BRAKES—AIR BRAKE FOOT VALVE REPLACEMENT—VEHICLES EQUIPPED WITH E14 FOOT VALVE	Article No. 02-23-5

FORD: 2000-2001 F-650, F-750

This procedure is to be used for 2000-2001 Ford F-650 and F-750 trucks that are equipped with air brakes and utilize the Bendix E-14 foot valve. The supplier Bendix, has discontinued the E-14 series foot valve in which the E-7 series foot valve has been identified to meet Ford application criteria.

Figure 1 - Article 02-23-5

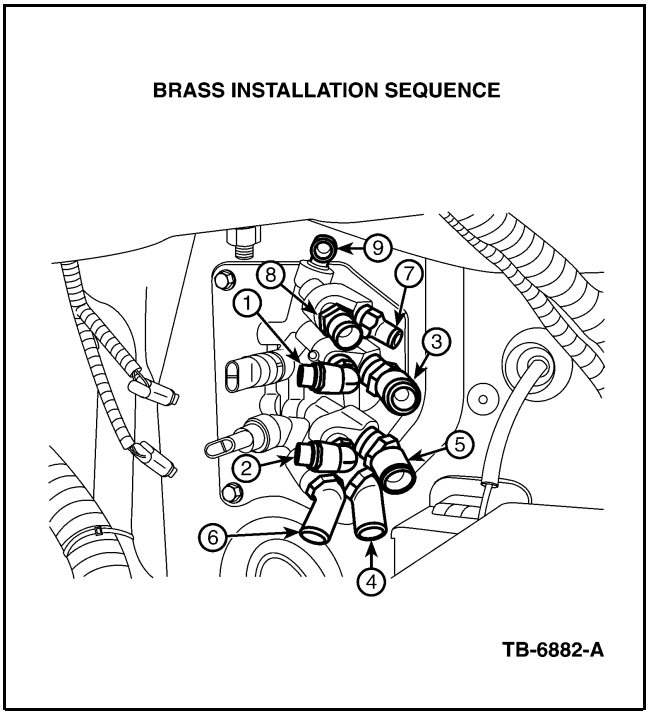
1. There is a sequence for installing the brass fittings into the foot valve (refer to Figure 1 for the sequence).

THE UPPER LEFT BOLT THAT ATTACHES THE MOUNTING PLATE OF THE FOOT VALVE TO THE DASH PANEL MUST BE PUT THROUGH THE PLATE BEFORE THE FITTINGS ARE PLACED IN THE VALVE.

Figure 2 - Article 02-23-5

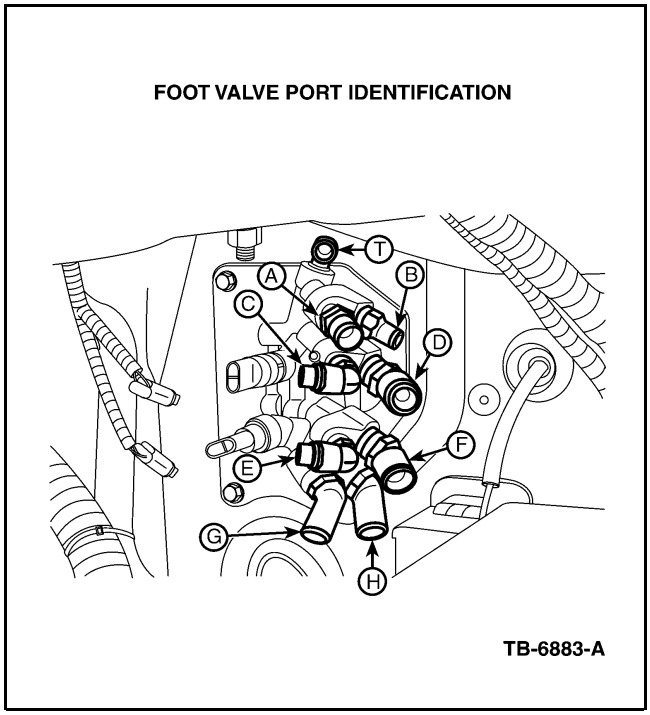
2. A foot valve port identification diagram has been provided to help identify ports (Figure 2). Mark all lines and ports prior to removing so as not to get ports and lines crossed. In reference to Figure 2, further explanation of port and connection are referenced as follows:

- Port A - Connects to Front Brakes - Red 3/8″ hose
   - Port B - Connects to Rear Brakes - Red 3/8″ hose
   - Port C - Connects to Air Manifold - Red 3/8″ hose

- Port D - Connects to Air Reservoir Tank - Red 5/8″ hose
   - Port E - Connects to Air Manifold - Green 3/8″ hose
   - Port F - Connects to Air Reservoir Tank - Green 5/8″ hose

- Port G - Connects to Rear Brakes - Green 1/2″ hose
   - Port H - Trailer Pkg Only - Connects to TP3DC (Tractor Protection Valve) - Green 1/2″ hose
   - Port T - Trailer Pkg. Only - Connects to TP3DC (Tractor Protection Valve) - Red 1/2″ hose

Figure 3 - Article 02-23-5

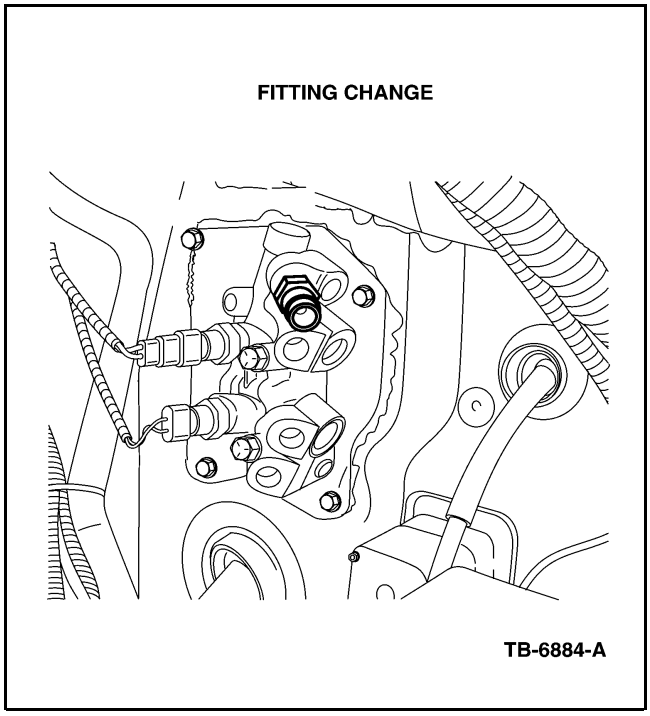
2. Replace 45 degree fitting in port A with new part F6HZ-2535-GA (straight fitting) and place in port A of the E-7 foot valve as shown in Figure 3.
3. All of the other fittings are to be transferred to their prospective ports on the E-7 foot valve as shown in Figure 4.
4. Install foot valve, place air lines into valve and check for leaks and proper operation.

Figure 5 - Article 02-23-5

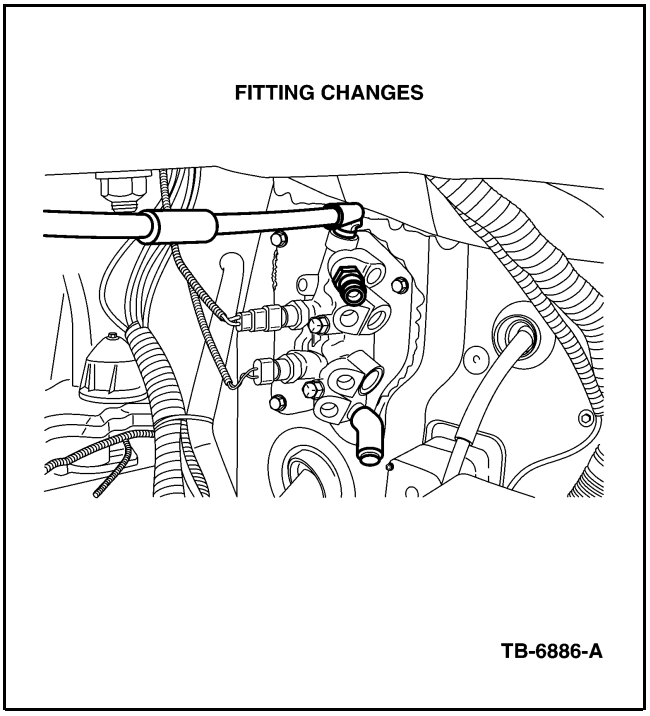
1. Remove E-14 foot valve from the vehicle.
2. Replace 45 degree fitting in port A with new part F6HZ-2535-GA (straight fitting) and place in port A of E-7 foot valve as shown in Figure 5.
3. Replace fitting in port H with new fitting F6HZ-2535-LB and install into port H on E-7 foot valve as shown in Figure 5.
4. Replace fitting from port T with new fitting F6HZ-2535-SB and install into port T on E-7 foot valve as shown in Figure 5.
5. Place 5 inches of 1/2″ I.D. red hose into fitting in port T, and then place connector 4C4Z-2535-CA onto end of hose, as shown in Figure 5. The air line going to port T can now be re-attached through the connector.
6. All of the other fittings are to be transferred to their prospective ports on the E-7 foot valve as shown in Figure 6.
7. Install foot valve, place air lines into valve and check for leaks and proper operation.

Figure 7 - Article 02-23-5

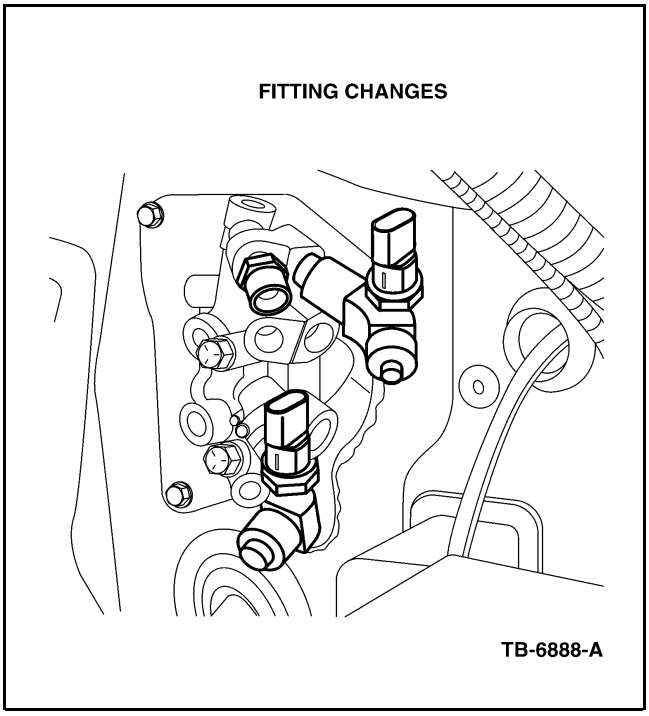
1. Remove E-14 foot valve from the vehicle.
2. Replace 45 degree fitting in port A with new part F6HZ-2535-GA (straight fitting) and place in port A of E-7 foot valve as shown in Figure 7.
3. Replace fitting in port B with new fitting YC3Z-2535-DA and place in port B as shown in Figure 7.
4. Replace fitting in port E with new fitting YC3Z-2535-DA and place in port E as shown in Figure 7.
5. All of the other fittings are to be transferred to their prospective ports on the E-7 foot valve as shown in Figure 8.
6. Install foot valve, place air lines into valve and check for leaks and proper operation.

Figure 9 - Article 02-23-5

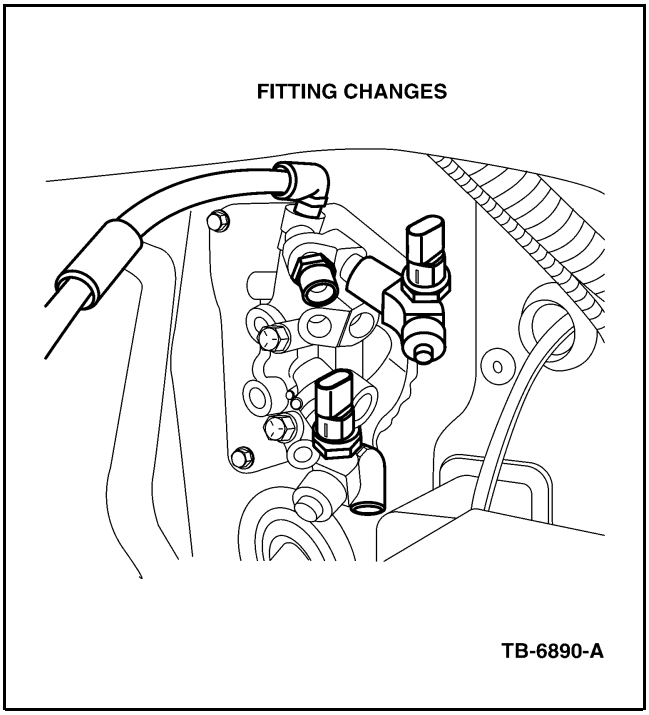
1. Remove E-14 foot valve from the vehicle.
2. Replace 45 degree fitting in port A with new part F6HZ-2535-GA (straight fitting) and place in port A of E-7 foot valve as shown in Figure 9.
3. Replace fitting in port H with new fitting F6HZ-2535-LB and install into port H of E-7 foot valve as shown in Figure 9.
4. Replace fitting in port T with new fitting F6HZ-2535-SB and install into port T of E-7 foot valve as shown in Figure 9.
5. Place 5 inches of 1/2″ I.D. red hose into fitting in port T, and then place connector 4C4Z-2535-CA onto end of hose, as shown Figure 9. The air line going to port T can now be re-attached through the connector.
6. All of the other fittings are to be transferred to their prospective ports on the E-7 foot valve as shown in Figure 10.
7. Install foot valve, place air lines into valve and check for leaks and proper operation.
